NEW AND EXPANDED SAFETY RECALL NOTICE

RE: IMPORTANT SAFETY RECALL NOTICE – NOVEMBER 11, 2011 RECALL OF ALL THOMPSON CENTER VENTURE RIFLES MANUFACTURED PRIOR TO OCTOBER 28, 2011.

**Punch mark visible
when bolt removed**

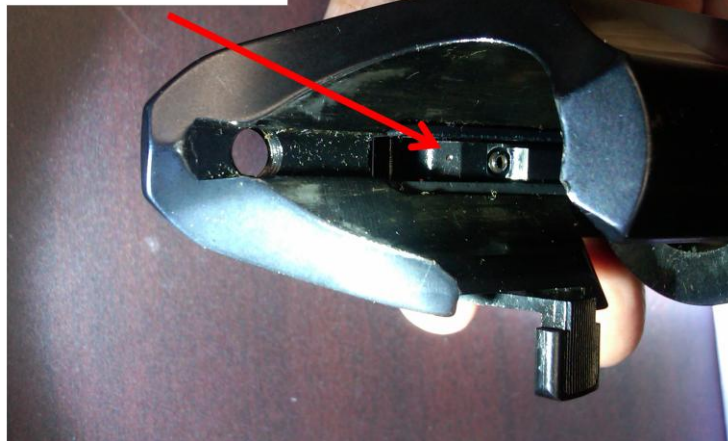
During an internal technical review, Smith & Wesson identified a condition that may exist with the sear supplied with some rifles that would allow the rifle to fire without the trigger being pulled. In the interest of consumer safety, we are initiating this recall to allow for the prompt inspection and, if necessary, the repair and replacement of each sear.

PRODUCT:	<u>ALL</u> Thompson Center Venture Rifles manufactured prior to October 28, 2011.
DESCRIPTION OF THE HAZARD:	During an internal technical review, Smith & Wesson identified a condition that may exist with the sear supplied with some rifles that would allow the rifle to fire without the trigger being pulled. In the interest of consumer safety, we are initiating this recall to allow for the prompt inspection and, if necessary, the repair of each rifle.
DESCRIPTION OF THE PRODUCT INVOLVED:	This broadens the recall announced by Smith & Wesson on November 8, 2011. This recall applies to <u>ALL</u> Venture rifles manufactured prior to October 28, 2011. To determine if your rifle is affected, please reference the serial number list located at www.smith-wesson.com/venturerecall or by calling Smith & Wesson directly at 1-800-713-0356. If your serial number does not fall within the list of affected serial numbers, your rifle is not part of this recall.

REMEDY/ ACTION TO BE TAKEN:	STOP USING YOUR RIFLE. Any unintended discharge of a firearm has the potential to cause injury or death, and we ask that you stop using your rifle until we have an opportunity to inspect the sear to make certain that there is no condition which will allow the rifle to fire without the trigger being pulled. To facilitate the inspection and, if necessary, repair of your rifle, please contact Smith & Wesson's customer service department to receive instructions and a prepaid return label for the return of your rifle to Smith & Wesson. When you return your rifle to Smith & Wesson, be sure to attach the completed information card received from Smith & Wesson, so that your rifle can be returned to you as quickly and efficiently as possible.
VERIFICATION OF CORRECTIVE ACTION:	When your rifle is returned, you should note a punch dot on the trigger assembly. See the photograph below. This punch dot is confirmation that your sear has been inspected and the hazard has not been found or has been corrected.

When your rifle sear is returned, you should also note a red checkmark on the label on the outside of your box. See the photograph above. This checkmark is further confirmation that your sear has been inspected and the hazard has not been found or has been corrected.
